IMPORTANT SAFETY RECALL NOTICE – SMART-STEER 2.0 Self-Steer Axle

Re: Safety Recall - Smart-Steer 2.0 Self-Steer Axle

SERVICE BULLETIN #009R

Subject: SMART-STEER 2.0 Bolt-On Steer Arm Reinforcement Welds

DETAIL A
SCALE 1:4

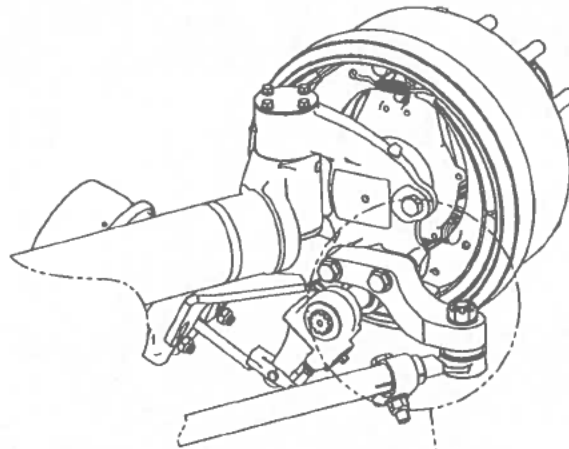
NOTE:
TURN KNUCKLE AT FULL TURN TO
GAIN ACCESS TO STEER ARM
AND WELD

1. Visually inspect steer arm bolts and washers for mechanical tightness and replace if necessary.
2. Ensure the steer arm bolts are torqued to 400 Ft. Lbs.
3. Place welds as shown on page three of this bulletin. If you would like a copy of engineering drawing 750049, please contact one of the service technicians listed below.

DETAIL C
SCALE 1:4

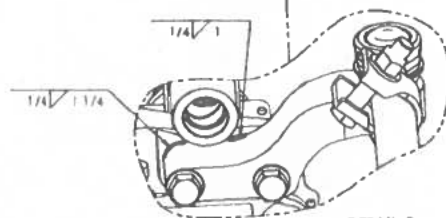
NOTE:
SOME COMPONENTS WERE
REMOVED FOR CLARITY.

DETAIL B
SCALE 1:4

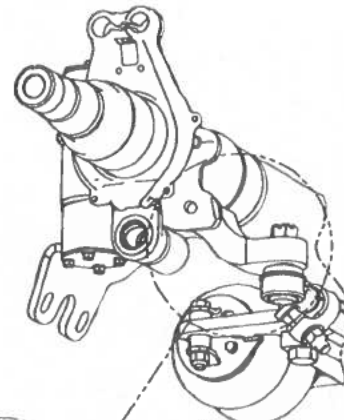
NOTE:
SOME COMPONENTS WERE
REMOVED FOR CLARITY
